PROPOSED CHANGE NO. 2

SOUTHWEST EXPERIMENTAL FAST OXIDE REACTOR

Re: LICENSE DR-15

Proposed Change No. 2
for the
Southwest Experimental Fast Oxide Reactor

FIG. 1: AMOUNT OF SODIUM LOST VS. LEAK RATE,
FOR 15 GALLON NET CHANGE IN REACTOR VESSEL SODIUM CONTENT.

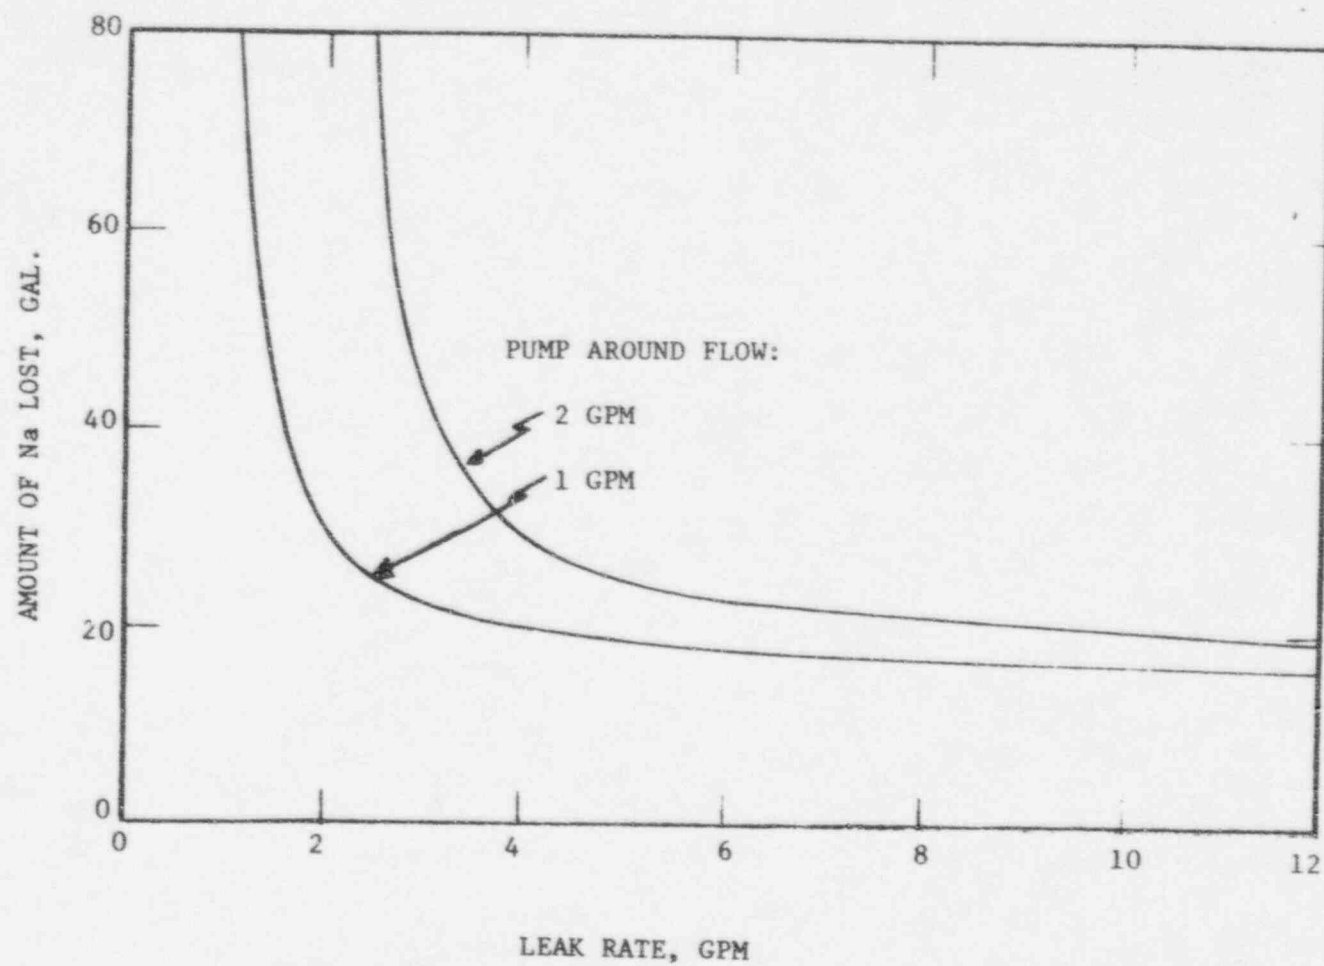
To alleviate this situation, it is proposed that the allowable pump-around flow rate be increased from 1 gpm to an average value of 2 gpm. Operational tests on the system have indicated that a nominal value of 2 gpm is the lowest flow rate at which the system can be operated and still eliminate the large number of spurious low flow alarms that have been experienced to date. Operational safety would be improved by elimination of numerous alarm signals which tend to divert the operator's attention, and through more stable operation of the pump-around-pump.

The new flow limit would allow the instantaneous flow rate to fluctuate around 2 gpm. However, the minimum detectable leak rate depends on flow rate over a period of several minutes. Therefore, any leak in excess of 2 gpm would be detected by the low level probes.

This change has a relatively small effect on protection afforded by the low sodium level probes. For leak rates significantly higher than the pump-around flow rate, the amount of sodium lost before detection occurs increases slightly when the allowable flow rate is increased to 2 gpm as indicated by Figure 1. This same figure shows that a larger change occurs over a narrow range of leak rates, from about 1-1/2 gpm to about 3-1/2 gpm. Protection against sodium leaks in this range and at rates below the pump-around flow rate is provided by the Na-24 monitor.⁽²⁾
